# Service Campaign Bulletin

Campaign No. 2018070013, August 2018

SUBJECT: **MY18 CLA-Class (117 platform)**  
**Check Seal on Left Tail Lamp, Rework if Necessary**

Figure 1

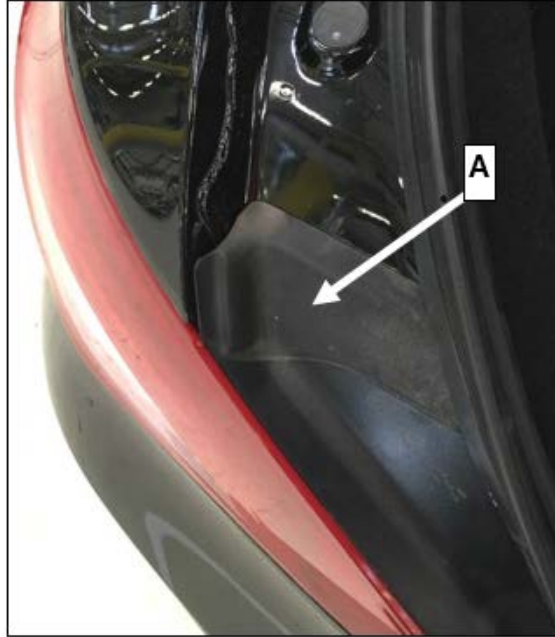
1. Check seam seal at left tail lamp (**figure 1**).
  - i** Fold forward cover (**A**) at tail lamp (**figure 2**).
    - a. If seam seal is **NOT** continuous and evenly applied: Perform work procedure.
    - b. If seam seal is **OK**: End measure.

1. Thoroughly clean area.
  - i** Before sealing, the treated area must be dry, free of grease and clean.
  - i** Fold forward cover (**A**) at tail lamp (**figure 2**).
  - i** The tail lamp must not be removed.
2. Rework seam seal at left tail lamp.
  - i** Apply transparent seam seal to area using a brush.
  - i** Please observe the seam seal completely dries.
